This errata sheet provides information about known device issues affecting Stratix® V production devices.

Production Device Issues for Stratix V Devices

Figure 1. ATX PLL Left and Right Sides

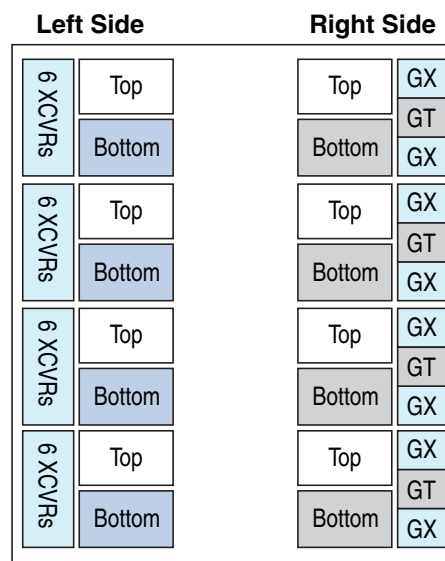
(2) Refer to Figure 1 for the Left side and Right side positions.

(2) Refer to Figure 1 for the Left side and Right side positions.
